CITY OF HOOD RIVER

BEFORE THE CITY OF HOOD RIVER PLANNING COMMISSION HOOD RIVER, OREGON

In the matter of a Conditional Use,
Planned Development, and Subdivision
application by Surround Architecture
to construct a 10-lot subdivision
for 8 townhomes & 2 detached single-
family dwellings called Hazel Ridge
PUD; File No. 2021-07

FINDINGS AND DECISION

Code section: City of Hood River Engineering standards for driveway separations on local streets.

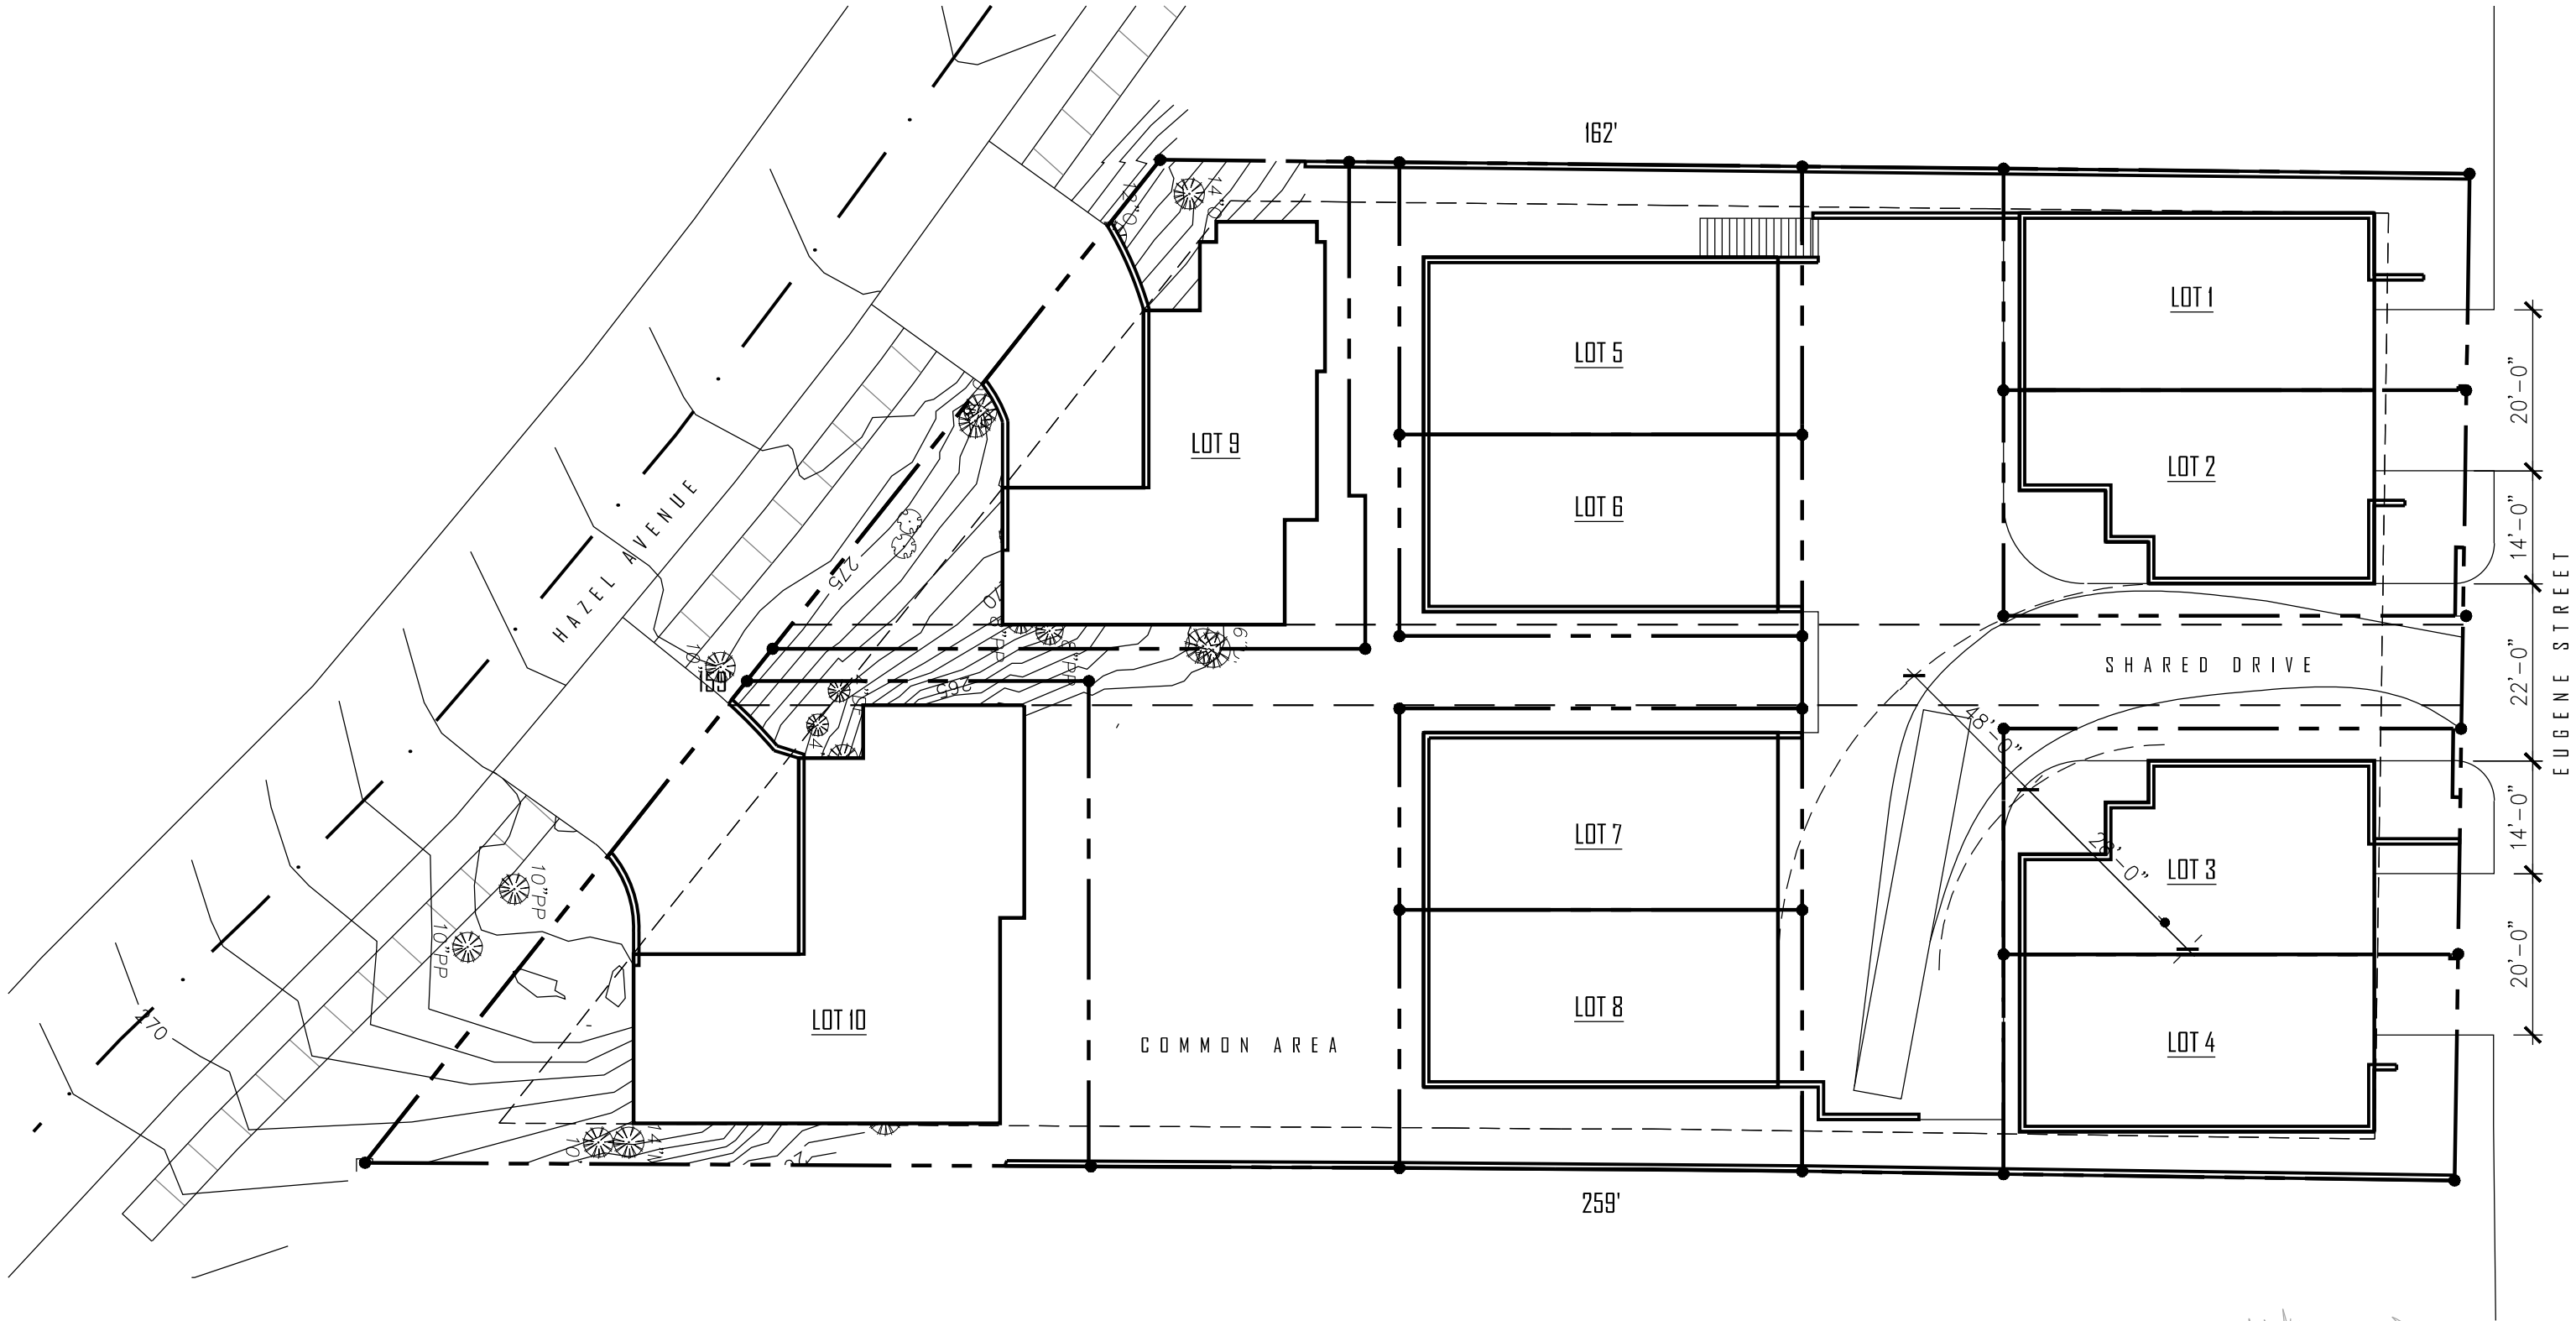
Proposal: allow 3 driveways on East Eugene Street, with 14' of separation between driveways (as shown on the attached option A), instead of the engineering standard of 22' + curb ramps.

Ability of Driver to see Traffic from Townhouse Driveway - East Edge of Property

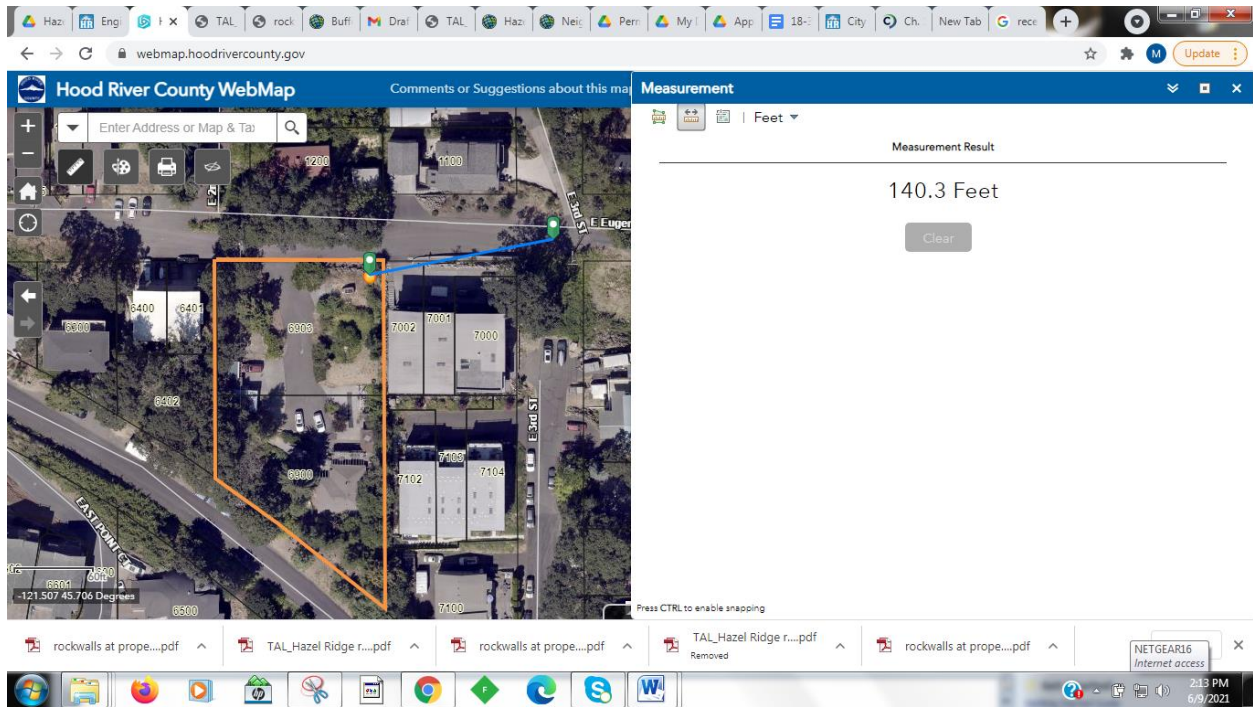
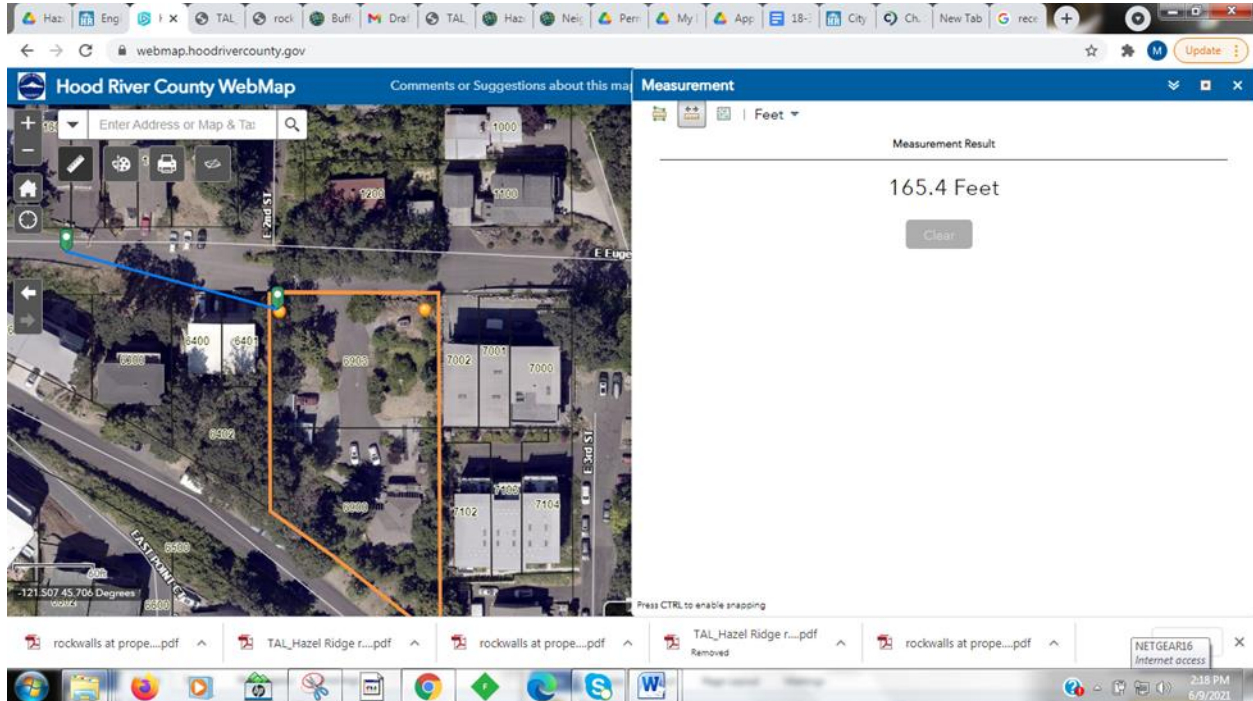
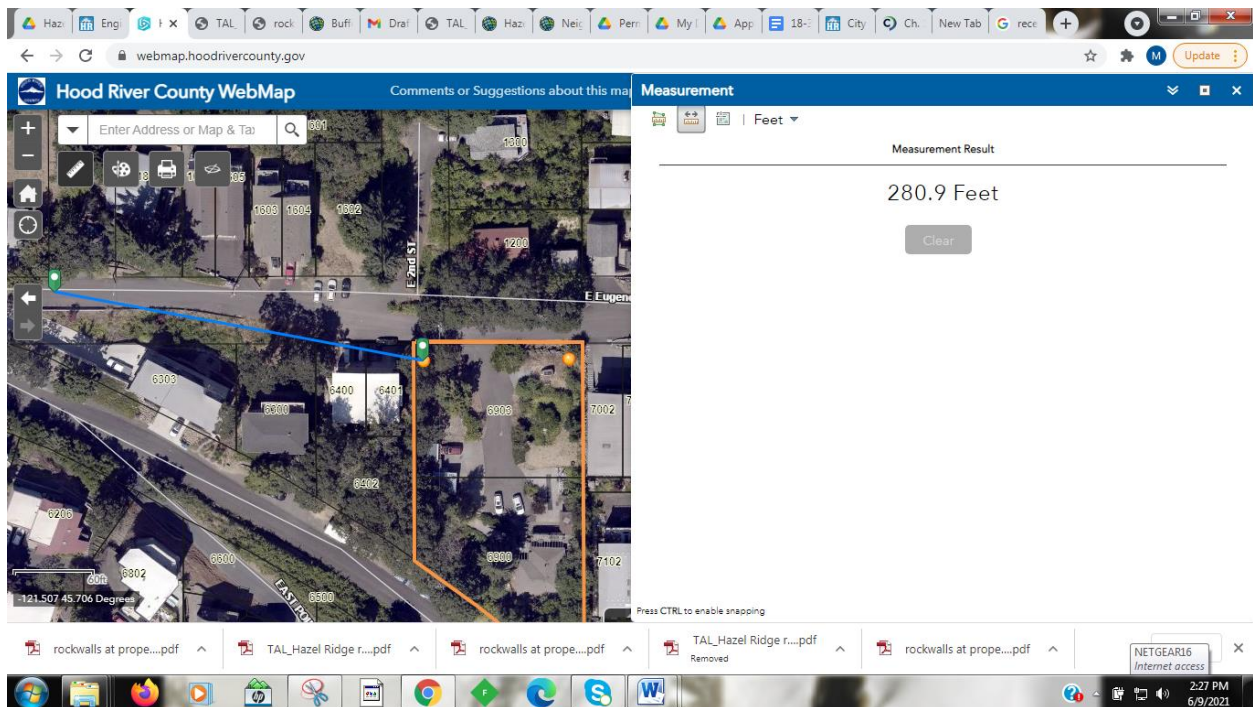
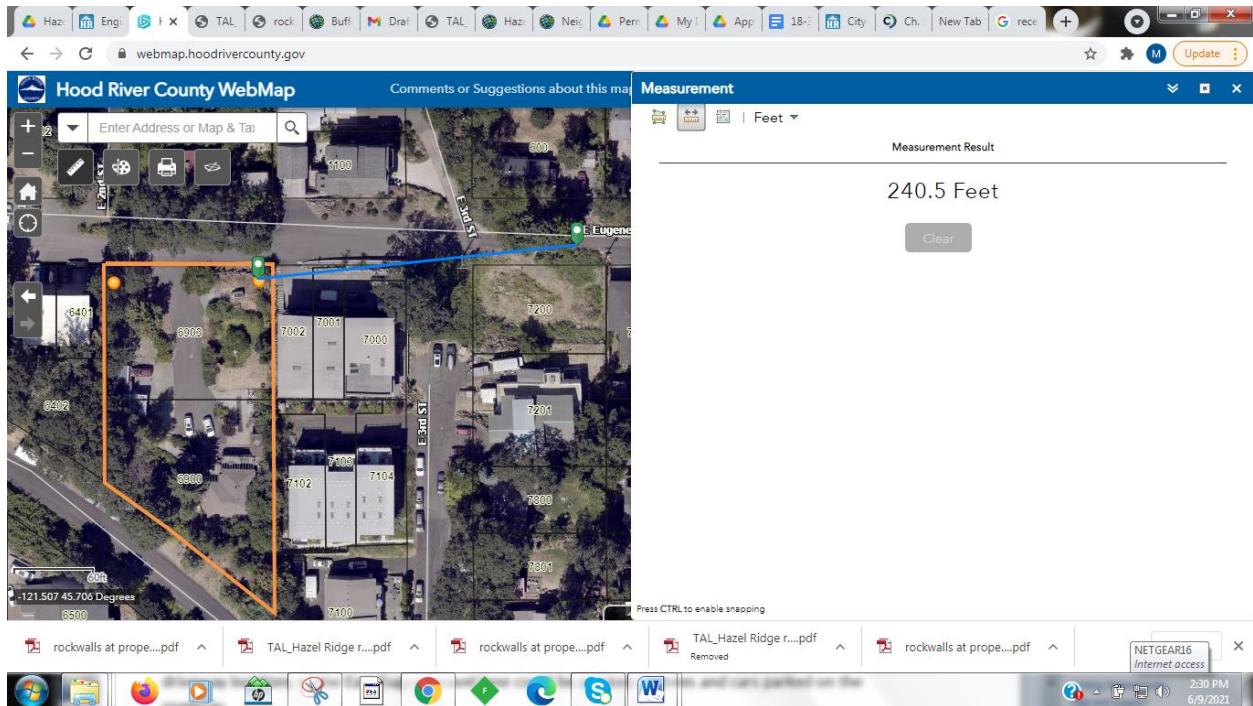
Site Distances Evaluated only for Shared Driveway and not Townhouse Driveways.

As shown on the site plan document A111 from Surround Architecture, there are 3 vehicle access points on East Eugene; two separate driveways for the townhouses facing East Eugene and one shared driveway to provide access to townhouses at the back of the development. In the Traffic Assessment Letter(TAL) from Bell Engineering dated 6.3.21, the site map and attached pictures only show an evaluation of site distances for the center shared driveway. A "planning level" evaluation using the County Web map and 2020 aerial imagery show that the driveways may have inadequate site distances to allow for drivers to see oncoming traffic. In the images below from the CountyGIS Web Map, a line was drawn from 15 feet back from the property boundary (distance TAL used), for a distance of 140 feet (Stopping Site Distance from TAL), to the approximate center of the East Eugene Travel Lane. The 2020 imagery shows the retaining wall on the adjacent property and indicates that the retaining wall may be blocking a driver's ability to see the road and/or other vehicles. A more detailed analysis based on the new grade at the townhouse locations would be required to definitively determine if there is sufficient visibility from the driveways to the East Eugene Travel Lane.

The same process was described above as used to evaluate a driver's ability to see the road and/or other vehicles for the West side Townhouses using the Stopping Site Distance of 165 feet from the TAL . Visibility from the driveway locations to the East Eugene travel lane could be blocked by trees and cars parked on the roadway.

Given the number of cars that will be accessing East Eugene from the 8 Townhouses and the complexity of the roadway (neighboring retaining walls) and the grade(6% and 9 % Bell Engineering) of East Eugene, intersection sight distances should be required by the City, as was done in the TAL at 316 East Eugene by Ferguson.
